SUBJECT: Response to NRC Query of Decommissioning Test Area C-74L, Eglin Air Force Base, Florida

SUBJECT: Response to NRC Query of Decommissioning Test Area C74L Eglin AFB FL

SUBJECT: Decommissioning Plan for Test Area C-74L, Eglin Air Force Base, Florida

Comments/Questions Related to Eglin Air Force Base Decommissioning Plan

FIGURE 1
IRP SITE NO. RW-41 TEST AREA C-74L
GUNNERY BALLISTIC FACILITY
PROPOSED SITE FINAL STATUS SURVEY
SOIL SAMPLING PROGRAM

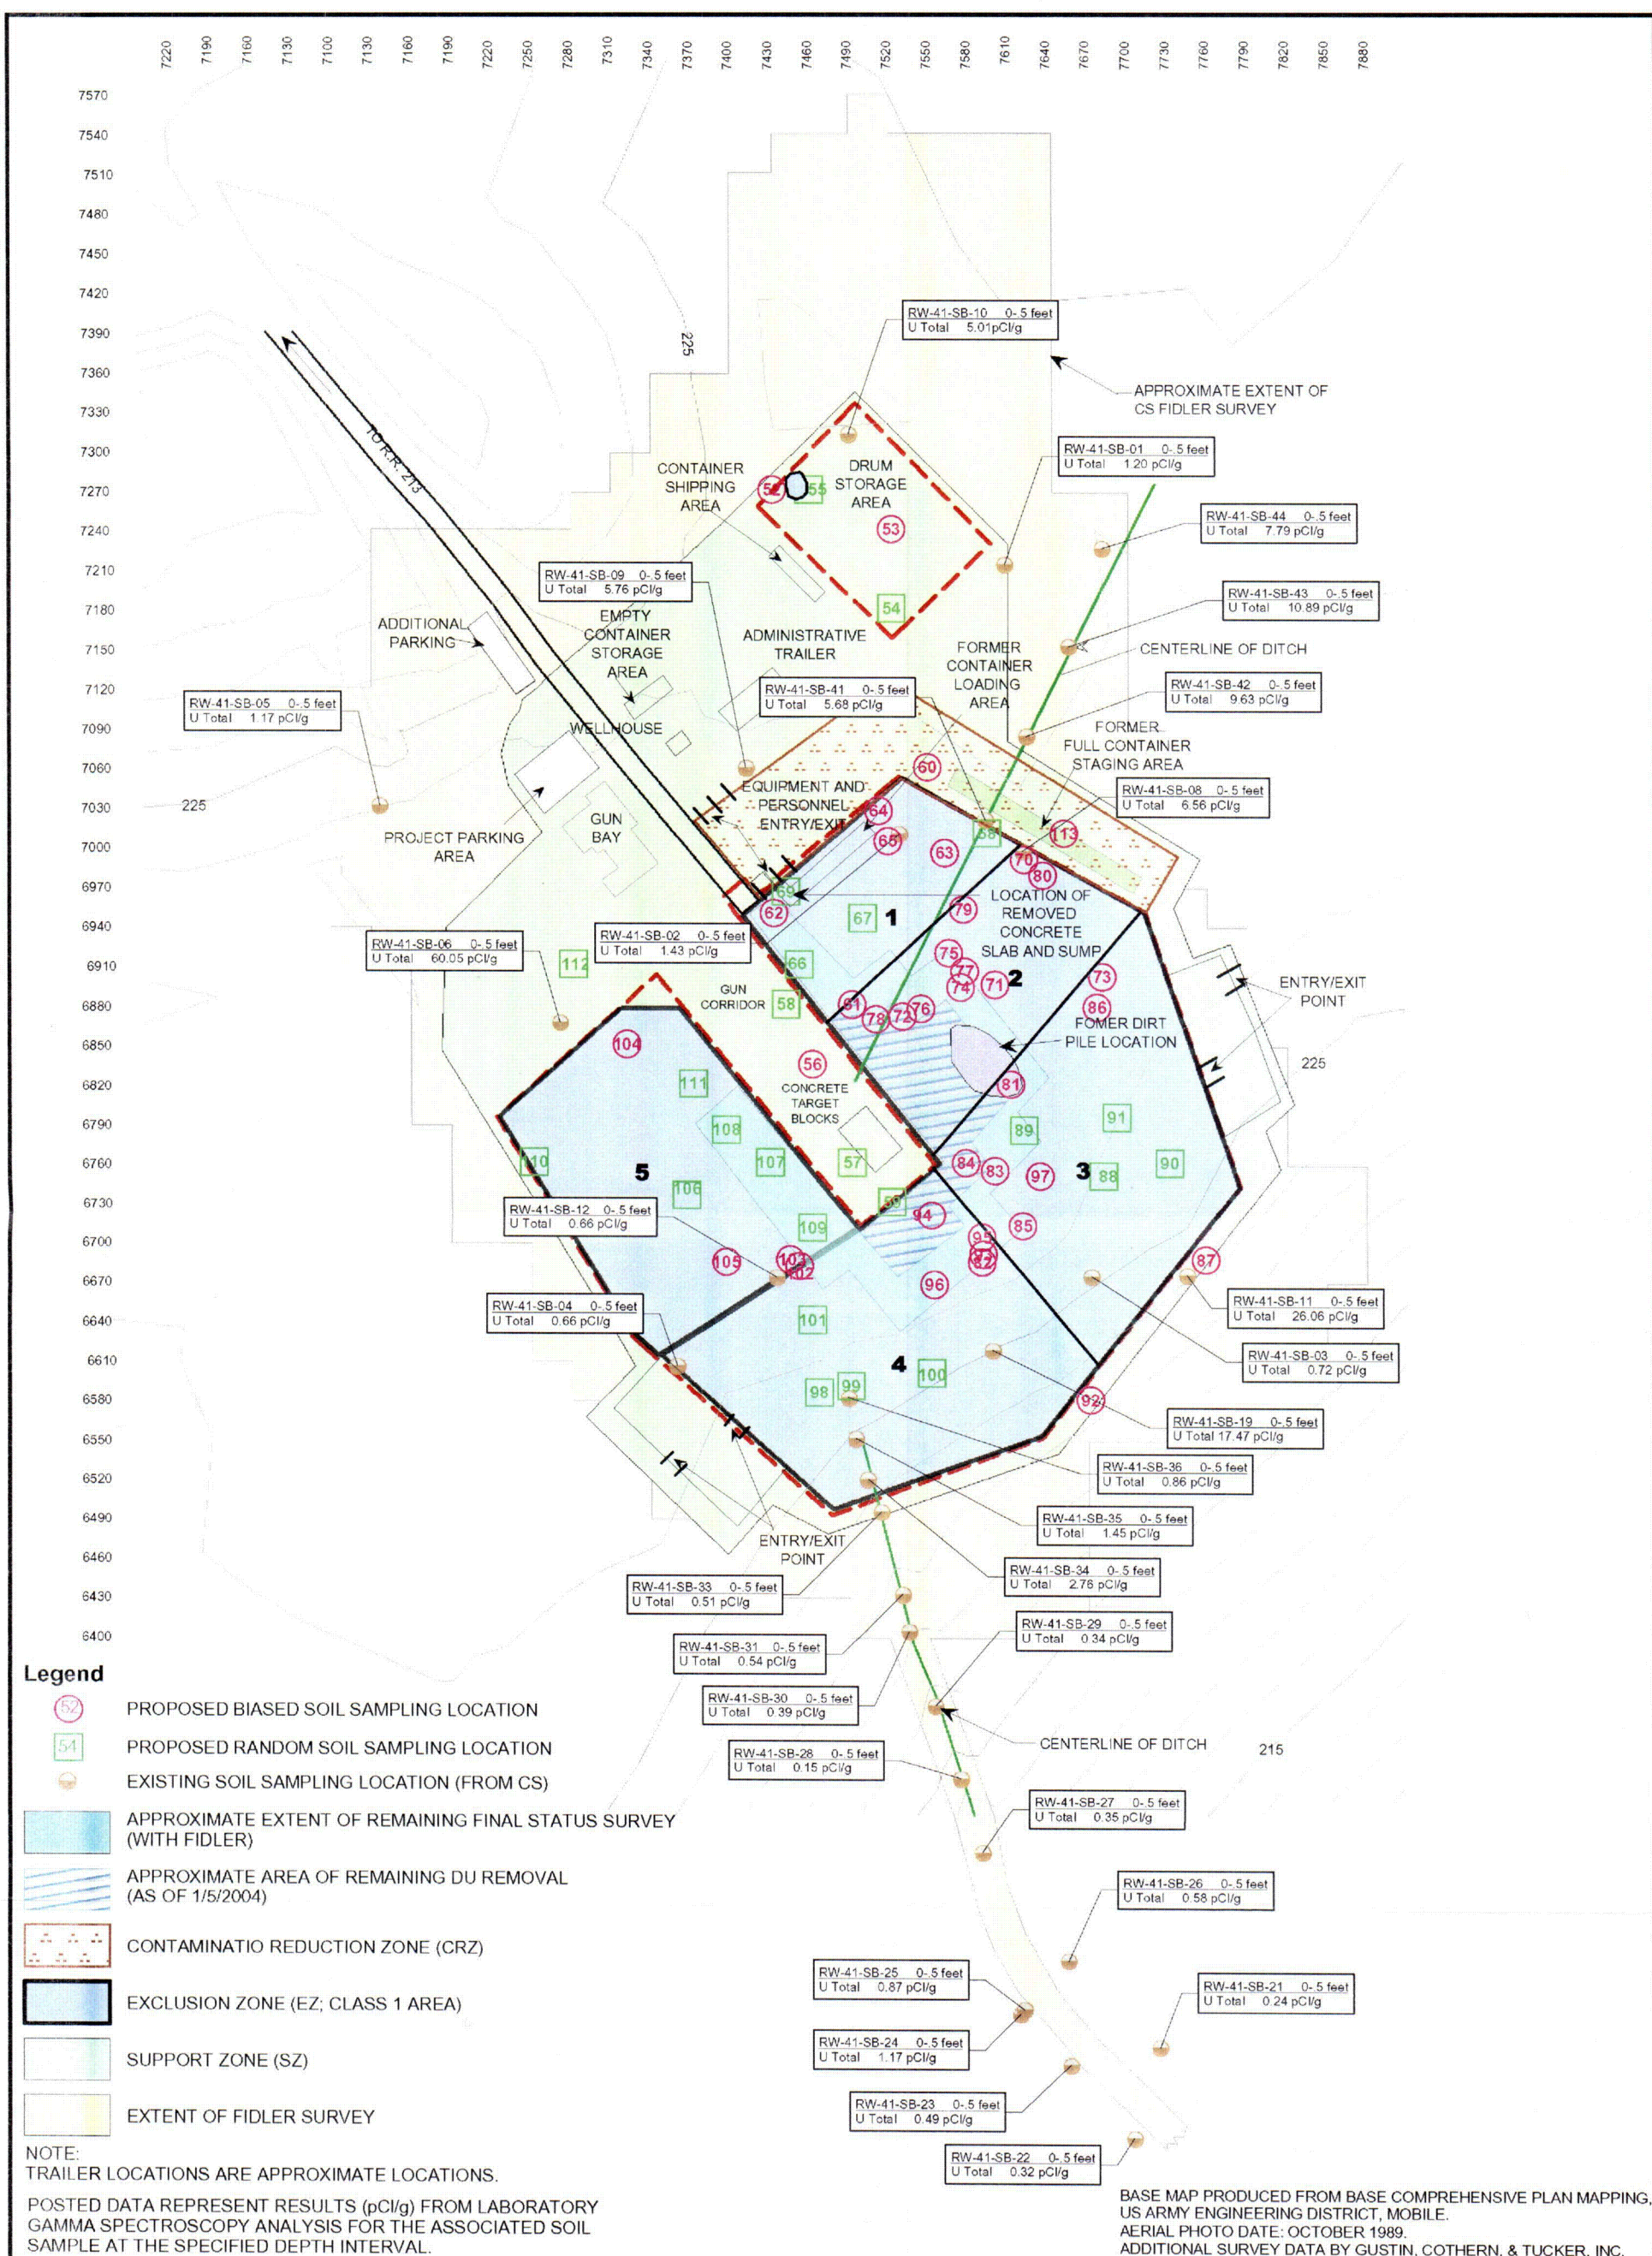
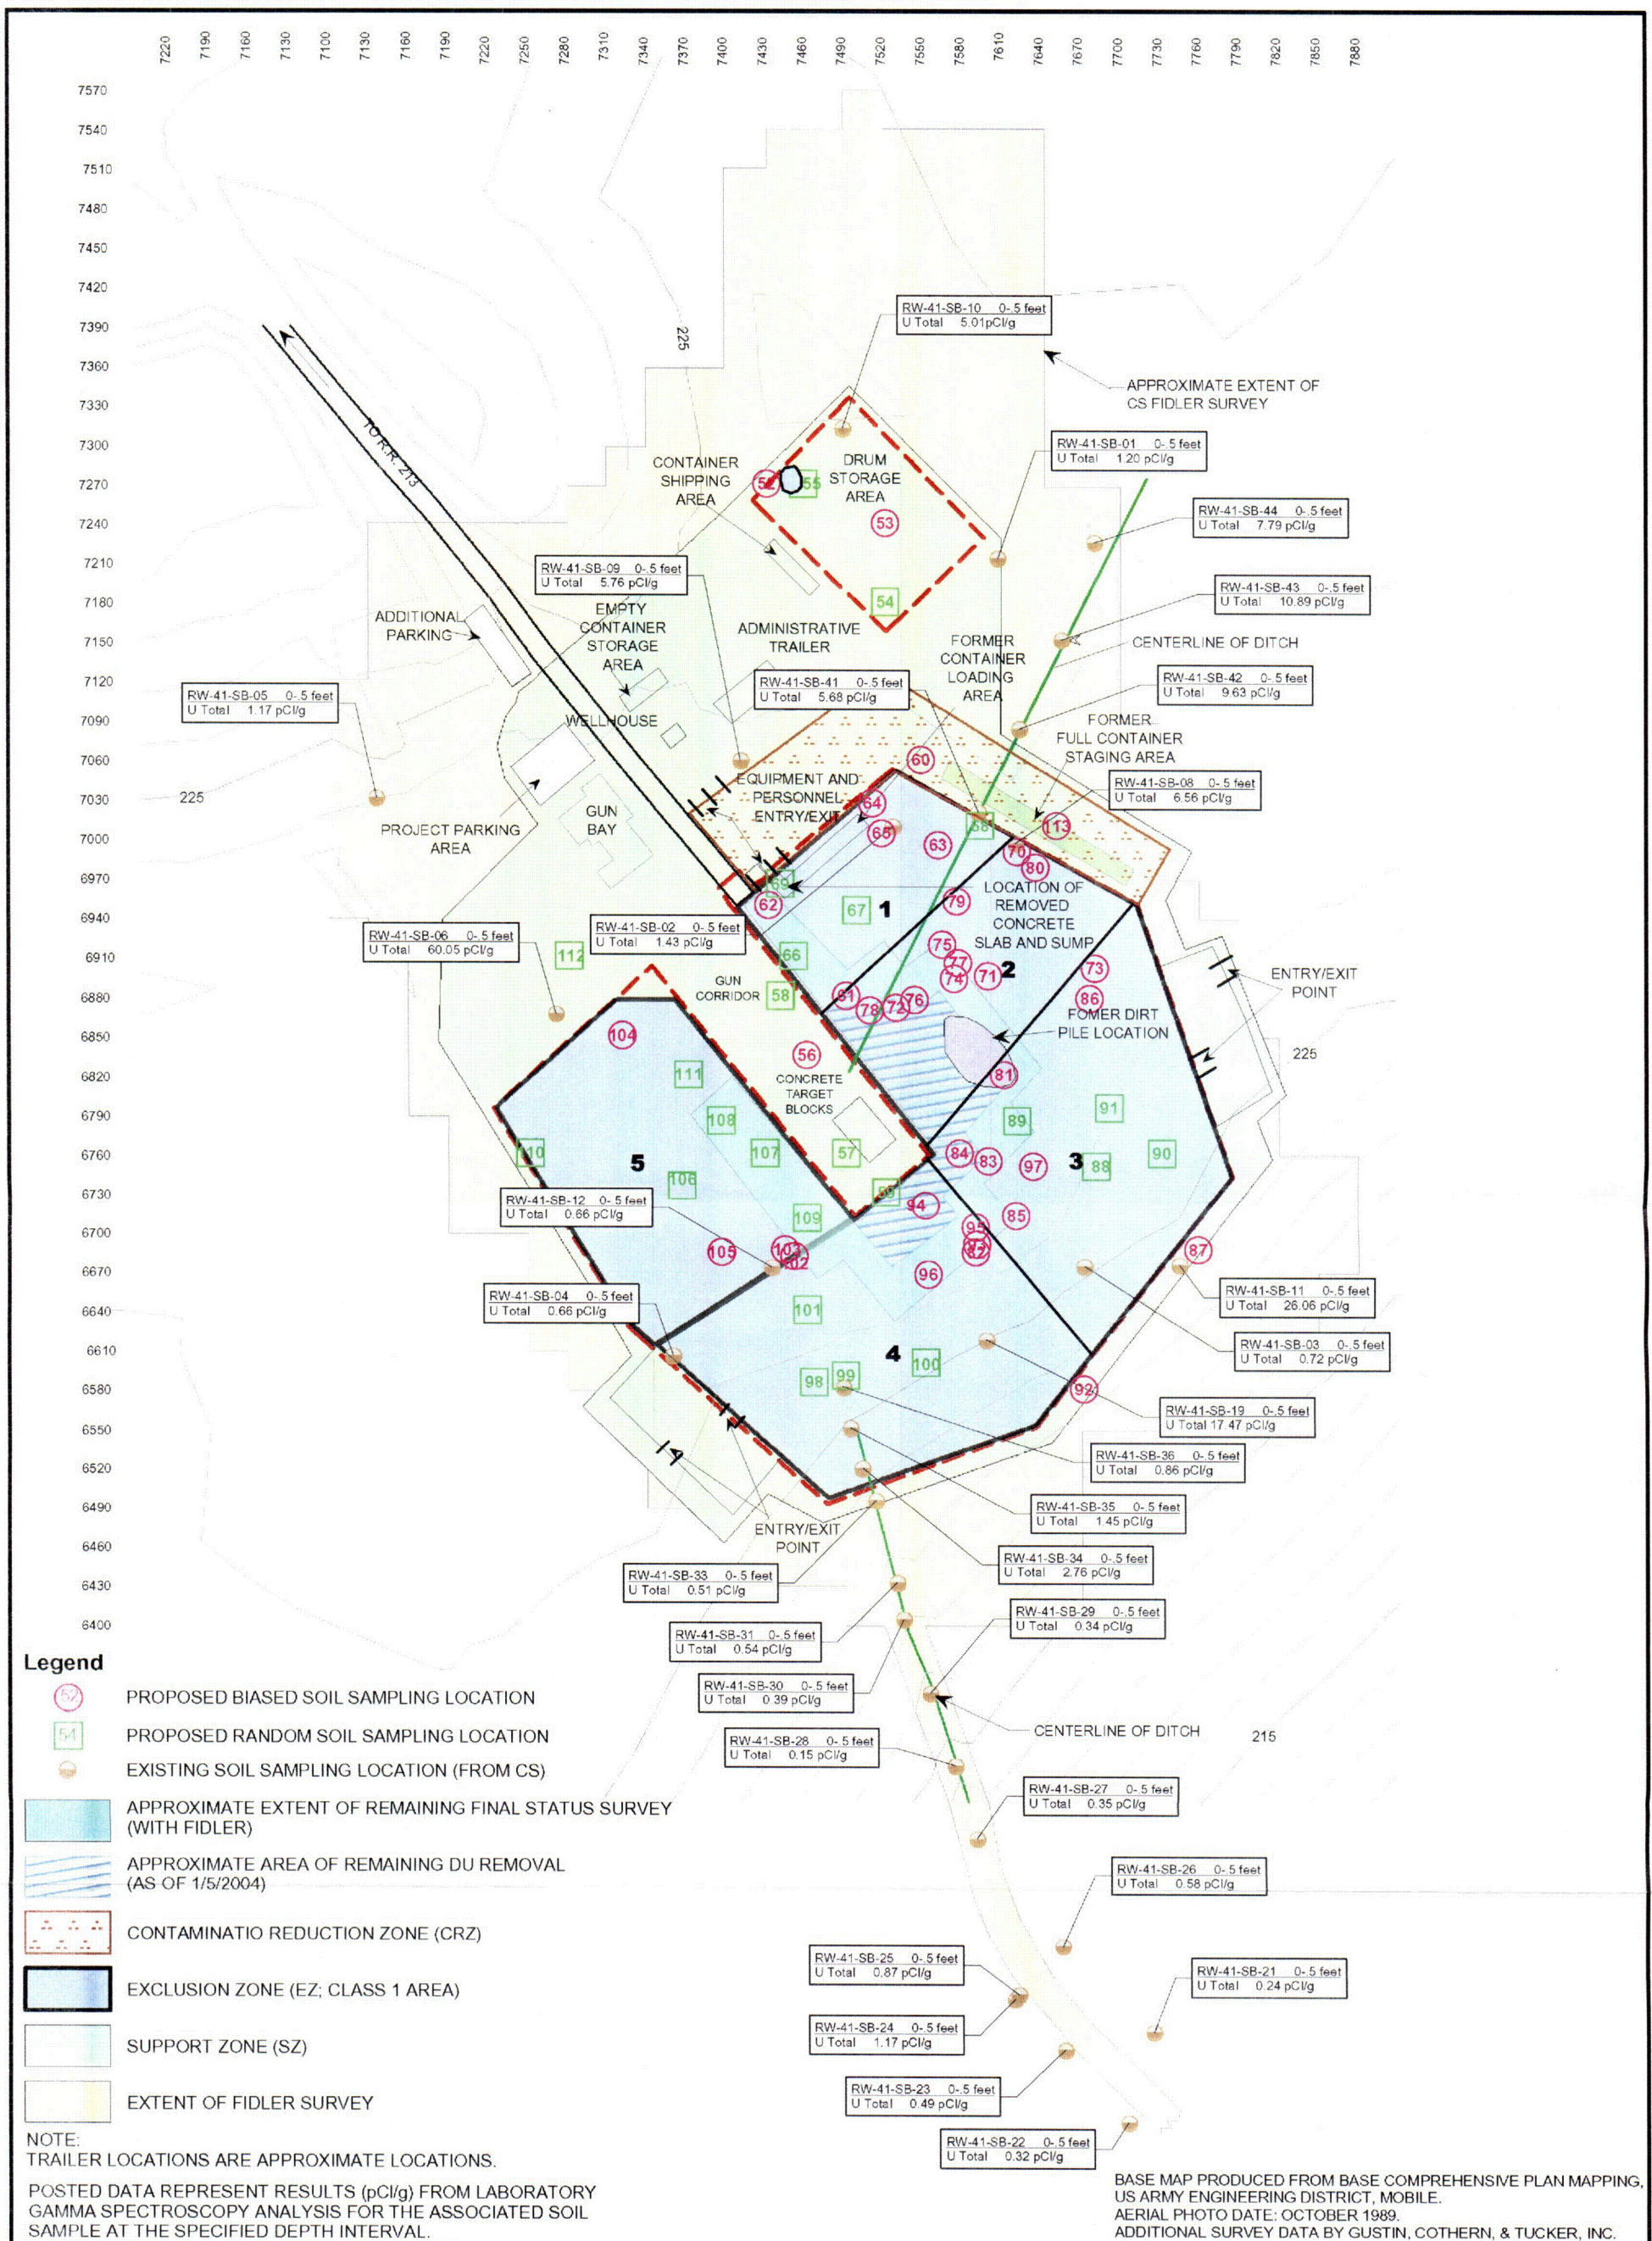
3. **The number of soil samples to be collected as part of the final status survey is inconsistent across the site. Please clarify the number of soil samples that will be collected site-wide and justify the proposed number if less than the number recommended in MARSSIM for each survey unit classification.**

The FSS soil samples will consist of three types: existing soil samples collected during the Characterization Study (CS) in 1999; new biased soil samples; and new random soil samples. The attached Figure 1 shows the locations of these samples. A total of 31 CS soil samples, 30 biased soil samples, and 30 random (unbiased) soil samples will be collected at locations within the gun corridor, former drum storage area, and Areas 1 through 5 of the radiation controlled area. This represents a total of 91 soil samples throughout the site.
